**STAFF RECOMMENDATION**  
**3903 A Kimpalong Avenue**  
**December 16, 2020**

**Application:** New Construction—Infill  
**District:** Woodlawn West Neighborhood Conservation Zoning Overlay  
**Council District:** 24  
**Base Zoning:** R10  
**Map and Parcel Number:** 10316012100  
**Applicant:** Michael Ward, Allard Ward  
**Project Lead:** Melissa Baldock, melissa.baldock@nashville.gov

A New Development for:  
**Hammond and Brandt Builders**  
3903A Kimpalong Avenue  
Nashville, Tennessee 37205

**A0.1**

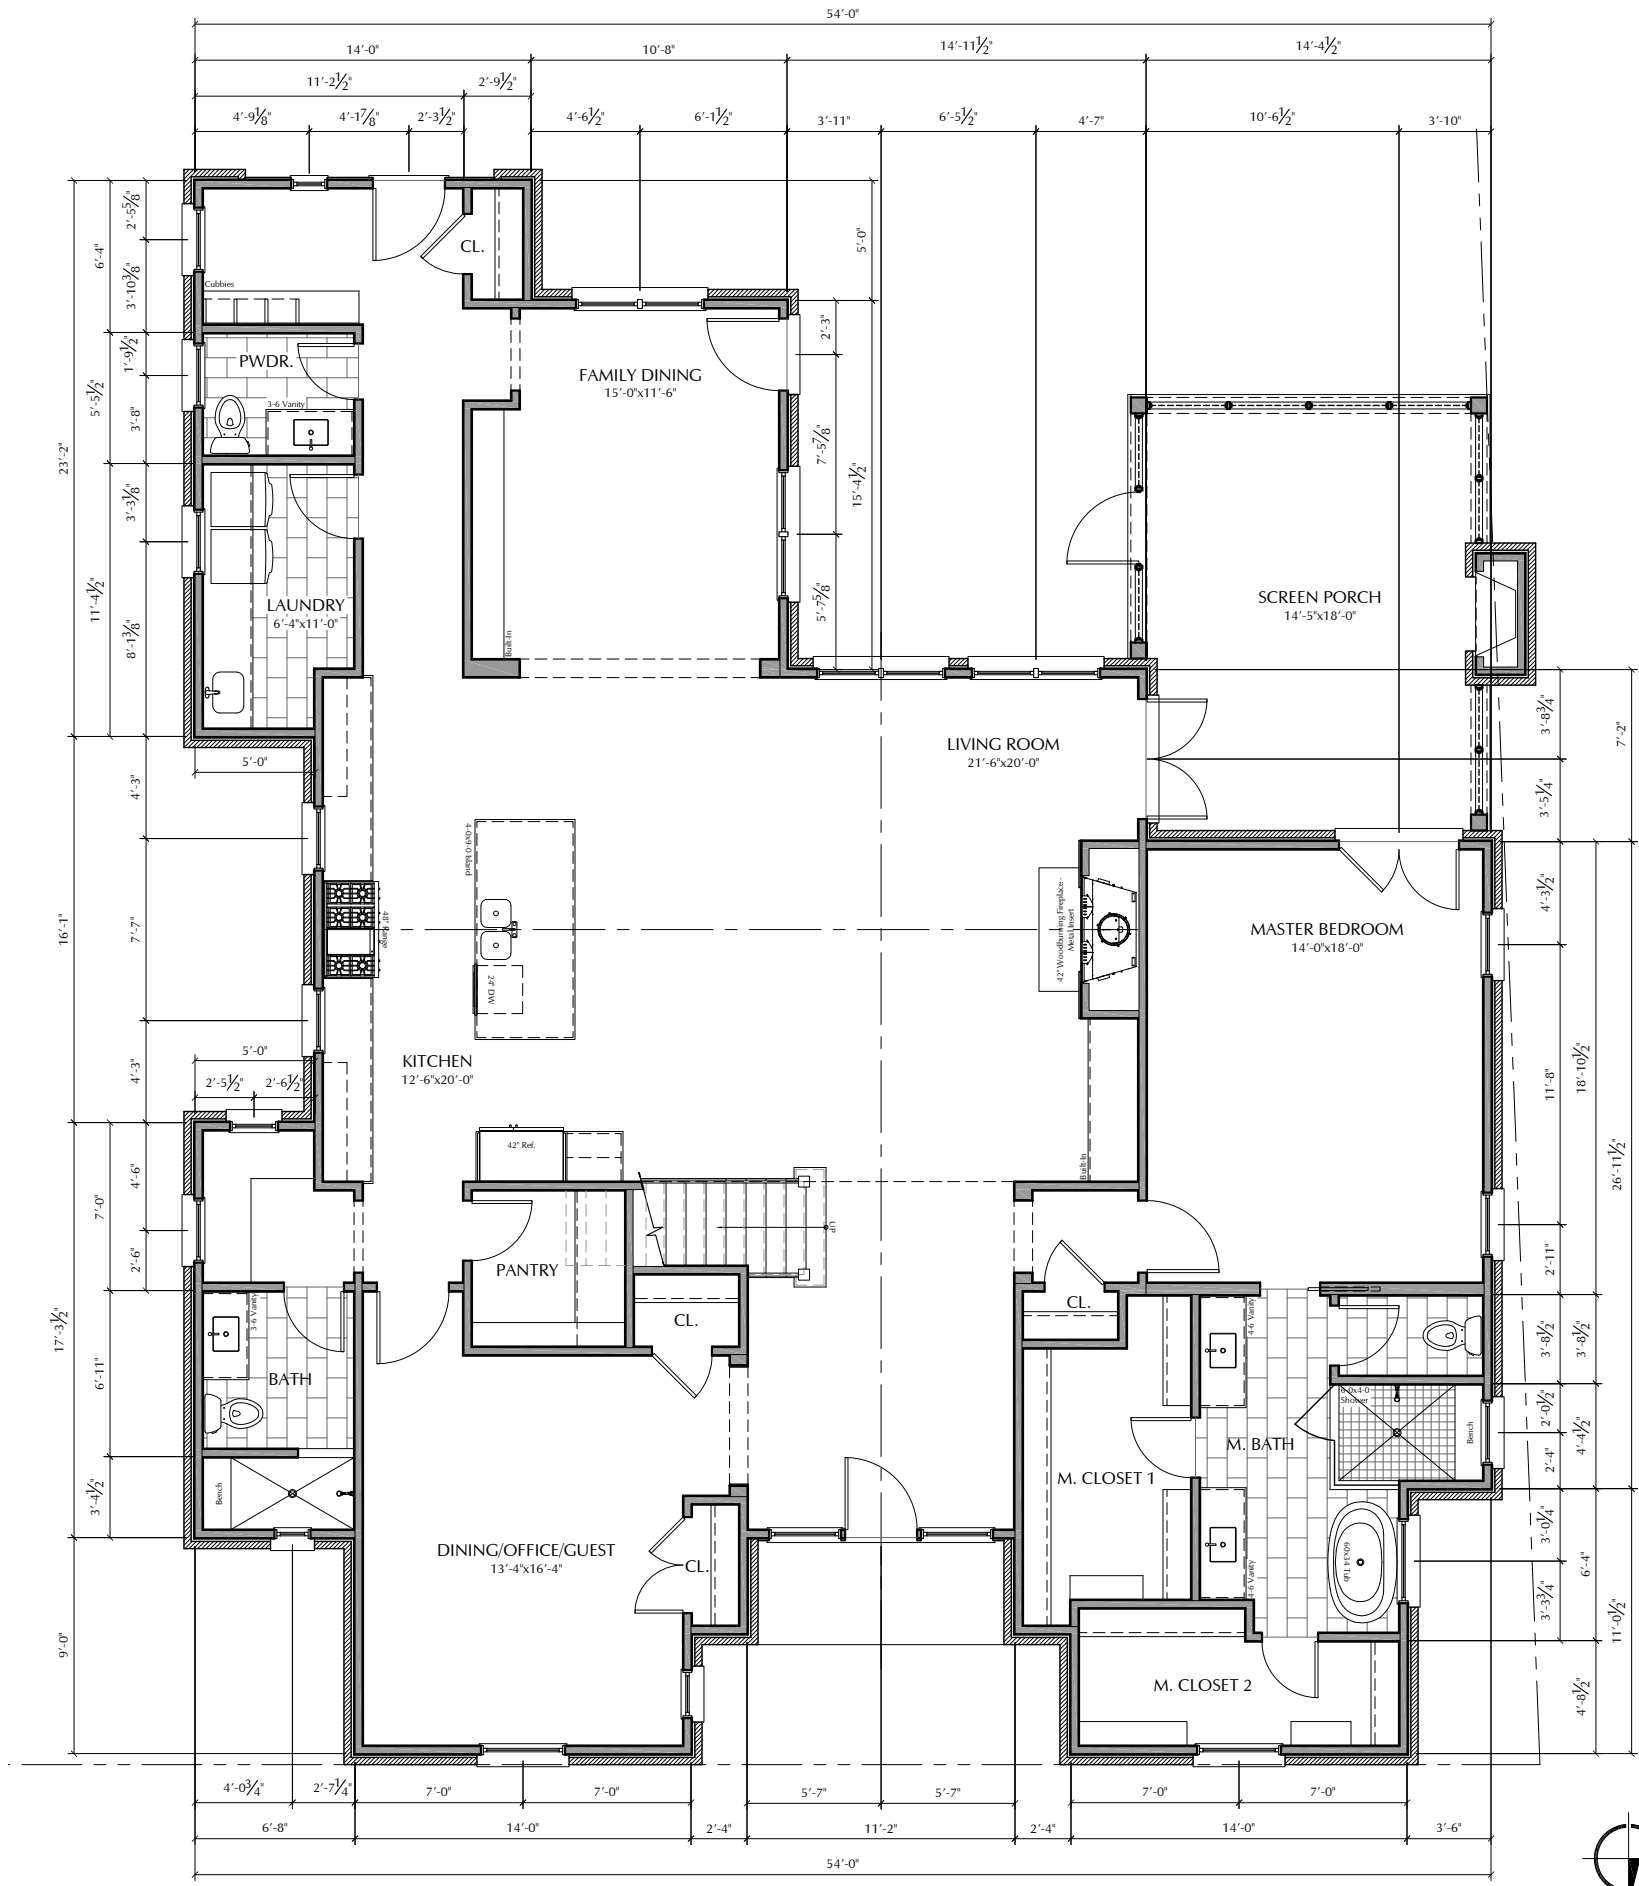
Setback & Rhythm of Spacing: The proposed infill meets all base zoning setbacks. It is shifted on the lot to retain the existing driveway. It will be 5' from the right-side property line, twenty-two feet (22') from the left side property line, and approximately forty-seven feet (47') from the rear property line. The front setback is drawn at approximately fifty feet (50'). The site plan shows that this lines up with the front setbacks of the houses on either side of it; staff therefore finds that the front setback meets the historic context.

Orientation: The infill is oriented towards Kimpalong Avenue, with a recessed front entry facing Kimpalong. The existing curb cut and driveway will be retained and used for the new infill. The site plan shows the front walkway as coming off the driveway rather than connecting to the street. This is similar to the existing walkway configuration. Kimpalong lacks sidewalks, and some of the houses have walkways leading to the street, but others do not.

**A1.2**

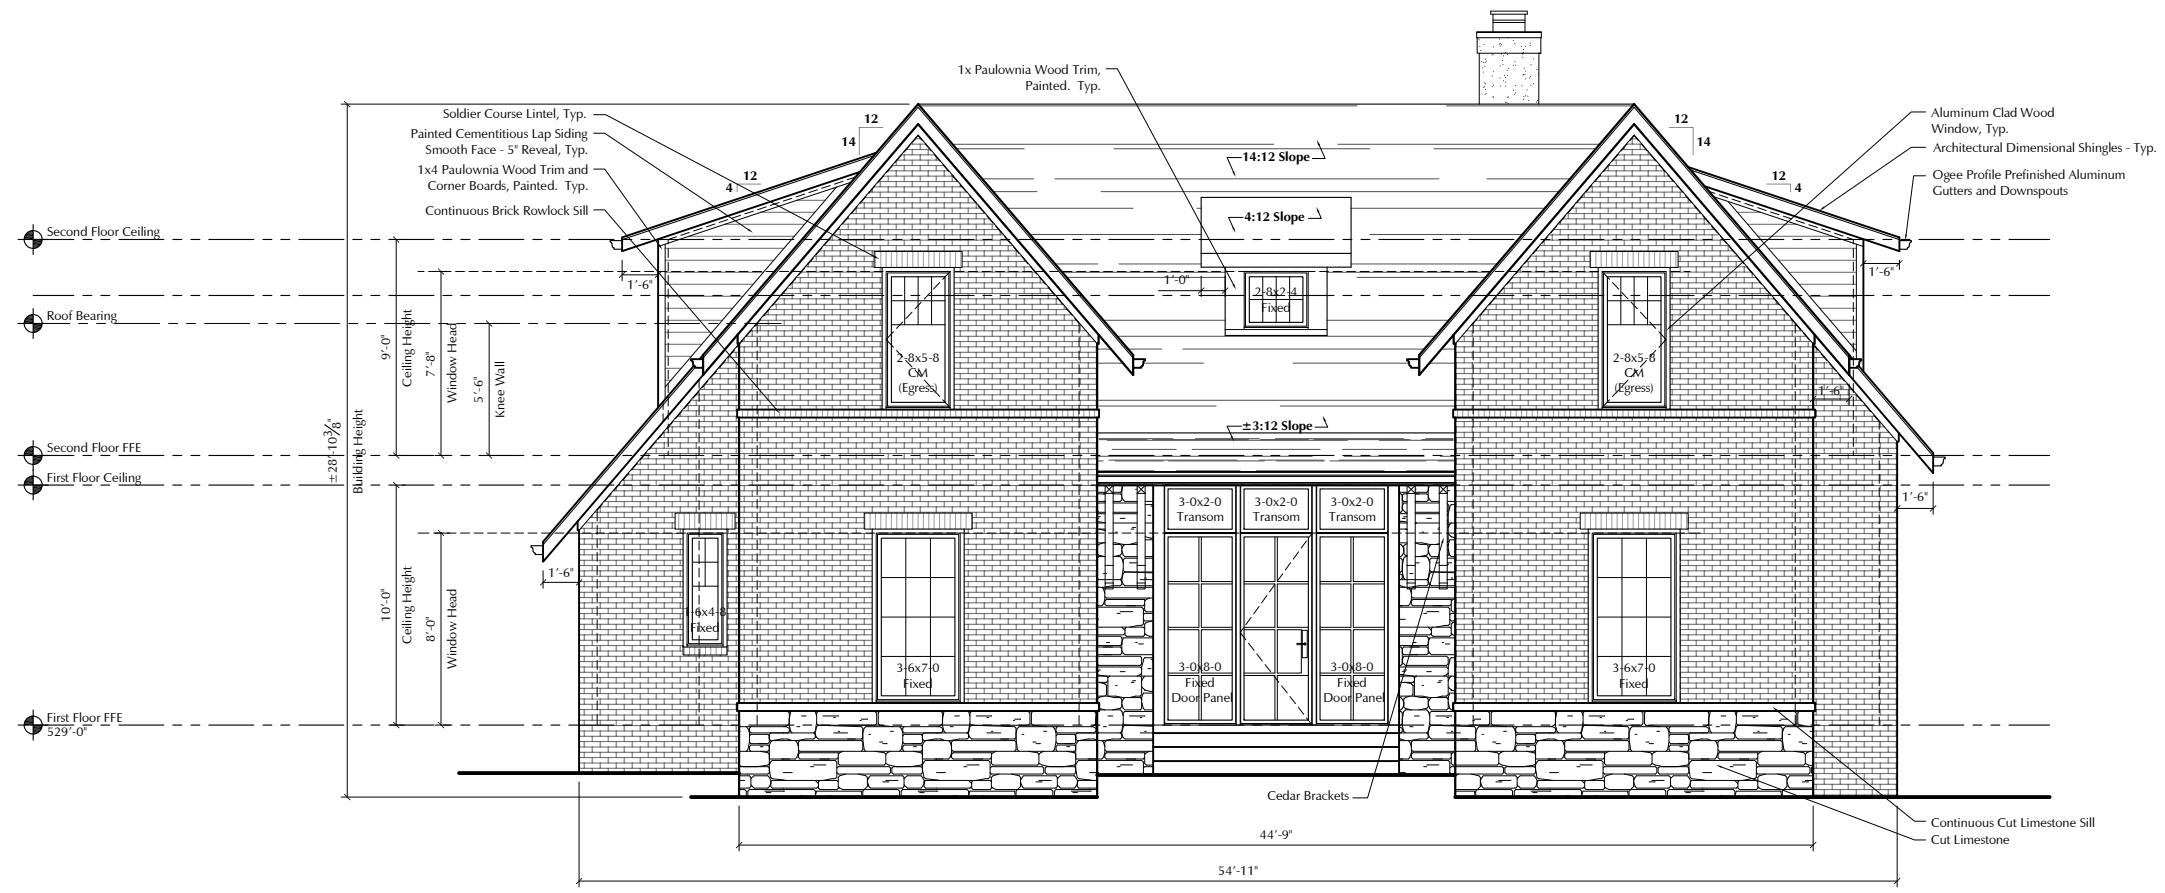
Roof form: The infill has two front-facing gables with 14/12 pitches at the front. These gables are connected by a 14/12 side gable form. The wider, one-story portions of the house have shed roofs, also with a 14/12 pitch. The gables on the side facades have 4/12 shed roof forms.

Staff finds that the infill’s roof form meets Section II.B.1.e. of the design guidelines.

**A2.0**

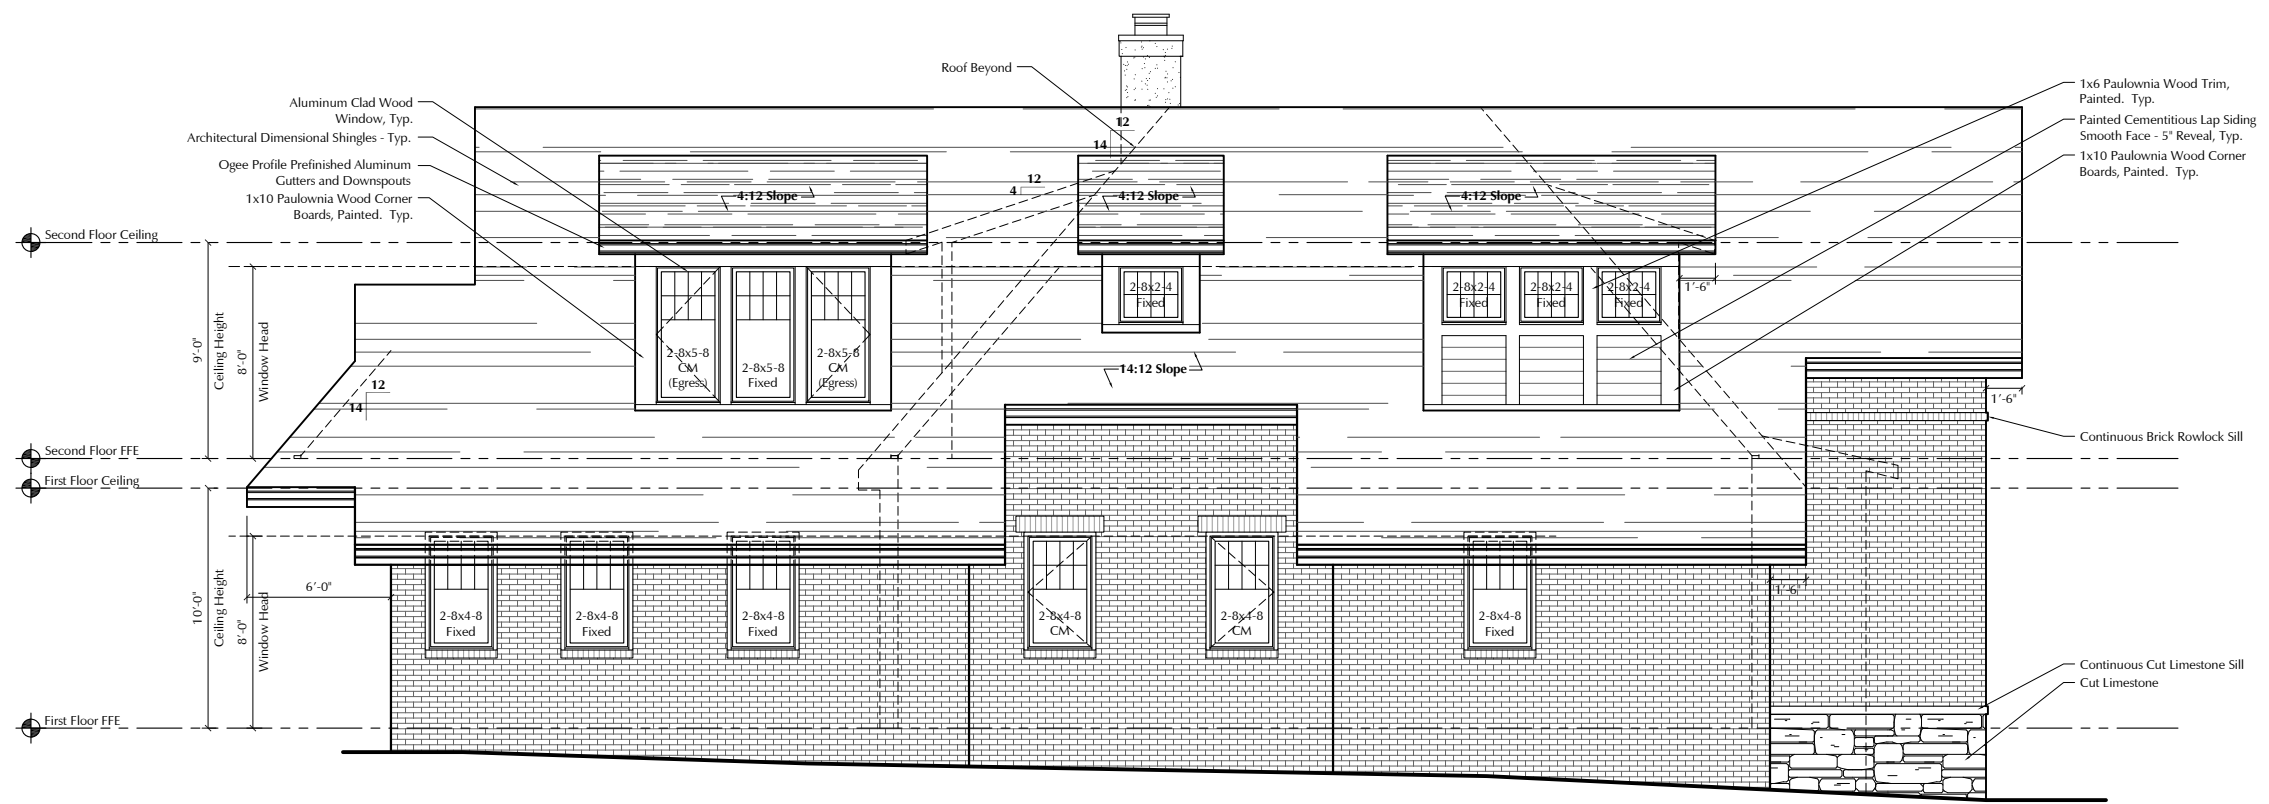
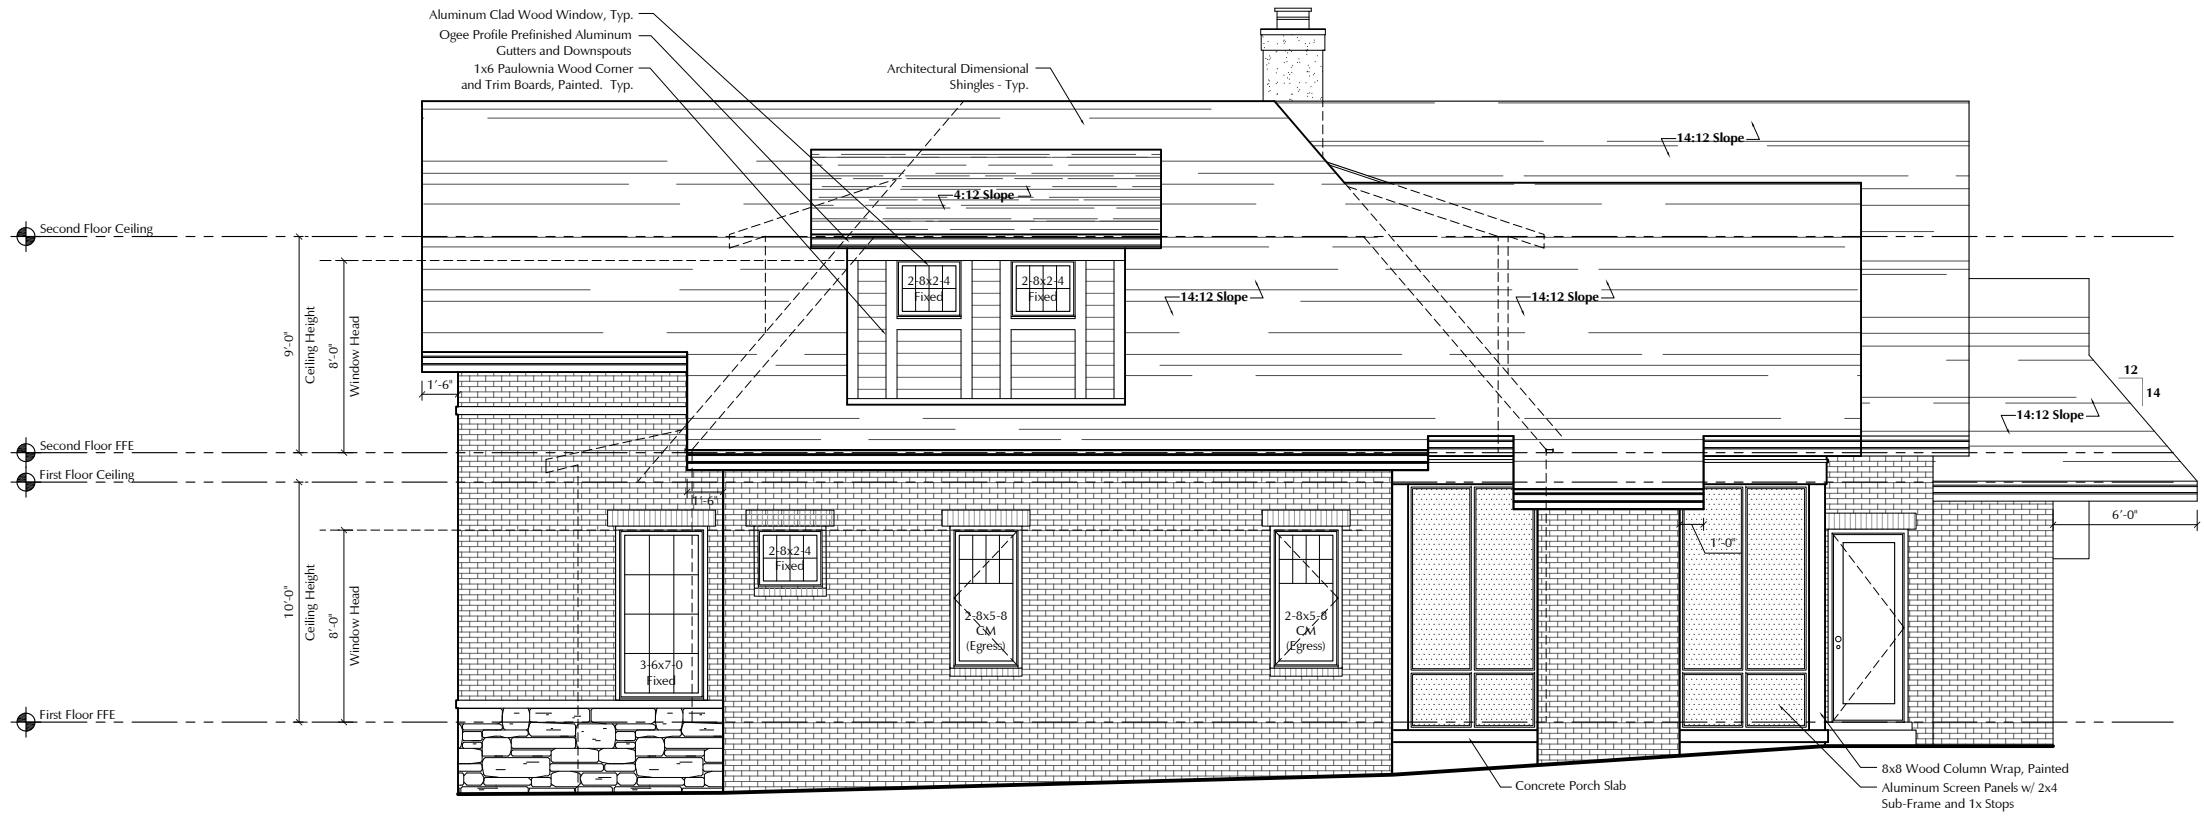
**Height & Scale:** The proposed infill will be one-and-a-half stories, which staff finds to meet the historic context which is largely one and one-and-half story houses. The infill will be twenty-eight feet, ten inches (28'10") tall at the front, which is in keeping with neighboring historic context where heights range from twenty to thirty-one feet (20'-31'). It will have a total width of fifty-four feet, eleven inches (54'11"), but the width of the one-and a half story portion is just forty-four feet, eleven inches (44'11"). The wider portions are just one-story in height. Staff finds that this is similar to several houses on the block where there is a main form of the house around forty-five feet (45') wide with one-story wings. Overall, the infill will have a footprint of two thousand, nine hundred, and sixty-two square feet (2,962 sq. ft.), which staff finds to meet the historic context and to be appropriate for the lot, which is over fifteen thousand square feet (15,000 sq. ft.).

\* While the front, one-and-a-half story portion of the house has a stone foundation, the side extensions and rear have a foundation that is brick to grade. Staff finds that brick to grade is appropriate for this street where there are stone and brick houses that do not have a change in material at the foundation line.

Proportion and Rhythm of Openings: Most of the windows on the proposed infill are twice as tall as they are wide, thereby meeting the historic proportions of openings. There are a few square windows, but staff finds that square windows were used sparingly in historic houses and therefore finds that these meet the historic context. There are no large expanses of wall space without a window or door opening.

1. The finished floor height be consistent with the finished floor heights of the adjacent historic houses, to be verified by MHZC staff in the field;
2. Staff approve all masonry samples, windows and doors, the front porch steps material, roof shingle color, and the driveway and walkway materials;
3. The HVAC be located behind the house or on either side, beyond the midpoint of the house.
